SUBJECT: Closure of Mynatt Ave between western right-of-way of Rule St and the northeast corner of Tax I.D. 108IIA024.
City Block 24302 & 24295
MPC File # 8-C-17-SC

8-C-17-SC-cor-KUB

**Re: Right-of-Way Closure Request 8-C-17-SC
Block No. 24302
CLT No. 108
Parcel No. 108AJ023**

File No. 8-C-17-SC Mynatt Ave. btwn Rule St. and parcel 108HA024 (Electric)

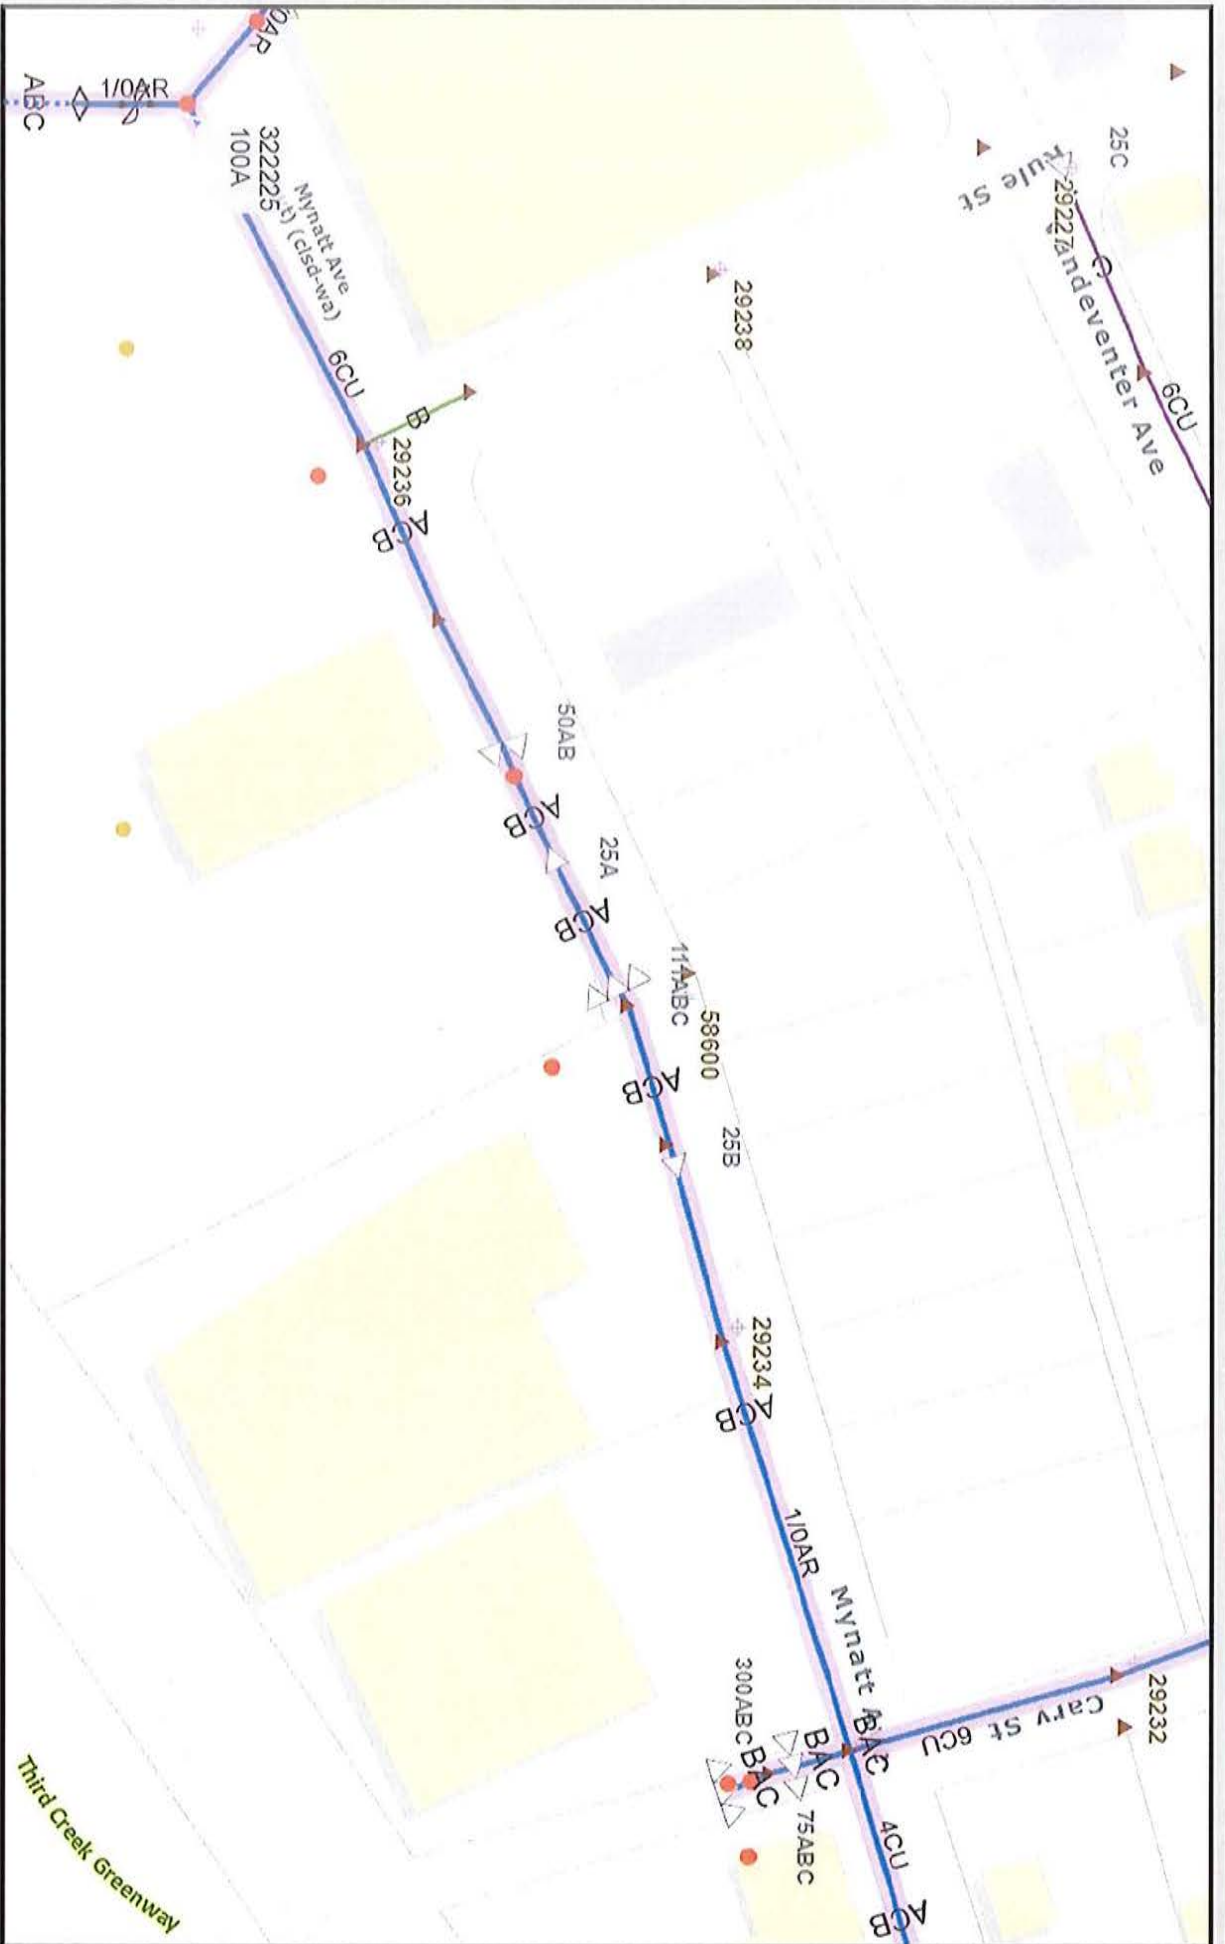
- Electric – 10 feet on each side of the centerline of the electric line, 20 feet total width
- Gas – 7.5 feet on each side of the centerline of the gas line, 15 feet total width
- Sewer – 7.5 feet on each side of the centerline of the wastewater line, 15 feet total width
- Water – 7.5 feet on each side of the centerline of the water line, 15 feet total width
